<div>Vendor</div> <div></div>	<div>ABT 360 KT/Y PP PLANT Project</div>		<div>Owner</div> <div><div>سراج گستران رجال SERAJ GOSTARAN REJAL (سهامی خاص)</div></div>
	<div>General Arrangement Drawing (incl foundation load details)</div>		
	<div>Vendor's Doc. No.: 2 3 2 4 9 - 0 4 A</div>	<div>Rev.: 02</div>	
	<div>PPEC Doc. No.: L03-RE037-ME-GAD-001</div>

Subject **GAD**
Gas Booster Compressor Package

28-4-2025
FvT
Plant Location
Scale
Airpack Ref. 23249-COM
Drawing No. 23249-04 GAD

A-A (FOUNDATION PLAN)

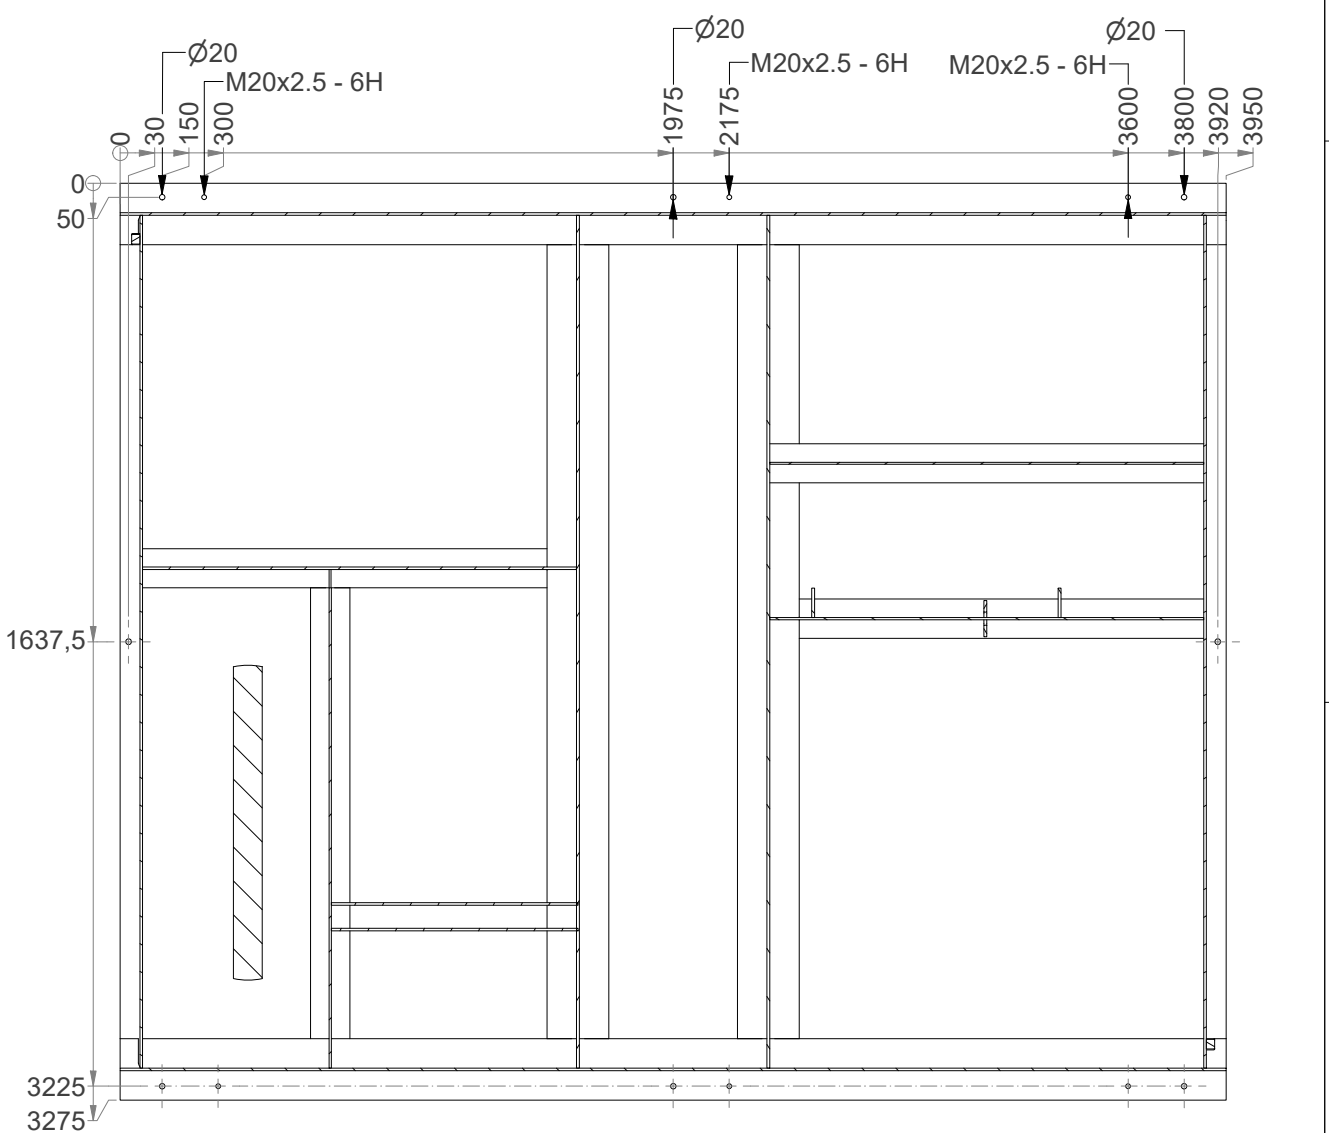
CIVIL LOAD MUST BE ADDED FOR FOUNDATION CALCULATION
